Staff Report & Recommendation

Historic Preservation Board

SUBJECT: HPB24-0632, **1730 Jefferson Avenue.**

The applicant has submitted plans entitled "Hill & Gamboa Family Residence", as prepared by DGO Architecture, dated June 17, 2025.

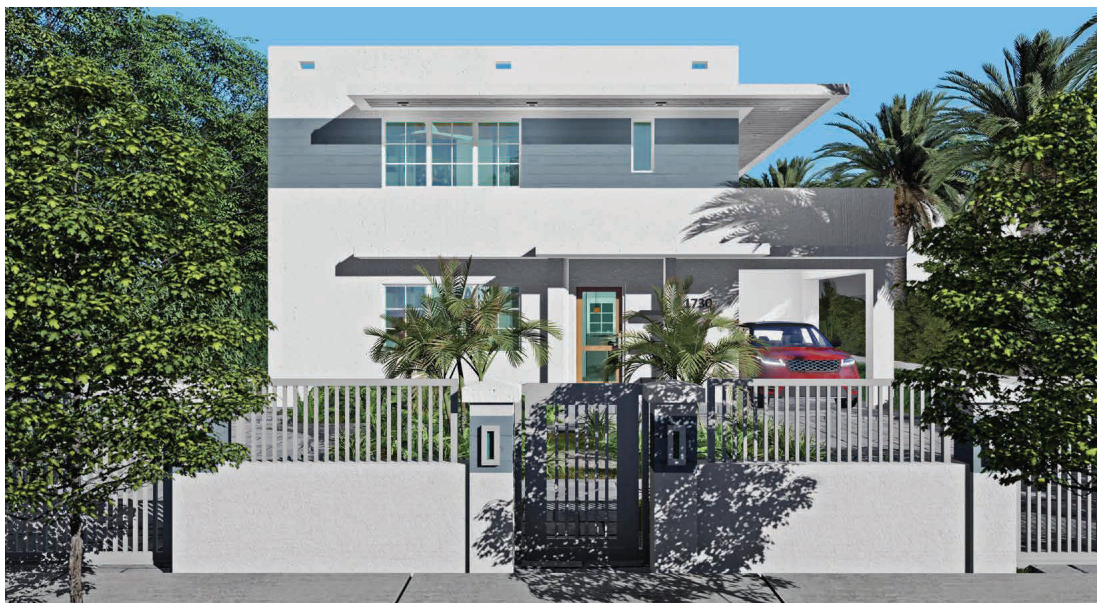
- The front façade of the home has been further refined including:
 - The retention of the racing stripes at the second level.
 - The introduction of historically accurate window muntins.
 - The proposed eyebrow/overhangs have been lowered closer to the top of the existing openings.

- The trim color has been lightened.
- The design of the front wall has been revised to include vertical pickets.
- The rear accessory building rooftop addition has been revised to comply with the required 15'-0" rear accessory building setback resulting in a reduction of the unit size variance request and the elimination of the rear accessory building setback, rear yard open space and rear yard lot coverage variances.

Staff remains supportive of the proposed additions which will not be visible from Jefferson Avenue. Further, staff believes that the modifications to the front façade of the home, as outlined above, are more consistent with the original design. Staff continues to be concerned, however, with the proposed new overhangs which are disconnected from the window and door openings and are not consistent with the original design. As such, staff recommends that the primary façade be retained and restored consistent with available historic documentation, inclusive of the retention and restoration of the existing eyebrows, or their reconstruction.

1. Revised elevation, site plan and floor plan drawings shall be submitted, and at a minimum, such drawings shall incorporate the following:
 - a. The primary (east) façade of the home shall be restored to the greatest extent possible, consistent with available historical documentation, in a manner to be reviewed and approved by staff consistent with the Certificate of Appropriateness Criteria and/or the directions from the Board.
